Regulation Number: 1,061

LEE COUNTY PUBLIC WORKS  
DEPARTMENT OF TRANSPORTATION  
LEE COUNTY, FLORIDA  
TRAFFIC REGULATION ORDER

Location: Luccett Road, from Ortiz Avenue to Golden Lake Drive

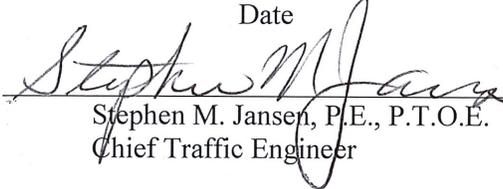
I hereby direct that the posted 30 MPH Speed Limit be changed to a 35 MPH Speed Limit

at the above named location, in accordance with the attached detail.

Studies on file: September 2020 Speed Study. Luccett Road is a collector road, and a 2-lane road in this section with residences on the north side and vacant County property on the south side. Luccett Road is posted at 35 Miles Per Hour from Golden Lake Drive to Country Lake Drive. Based on the roadway cross-section in this less than ¼ mile section, speed profile, and vehicle test runs, a maximum speed limit of 35 Miles Per Hour is appropriate and in accordance with FDOT Speed Zoning Guidelines.
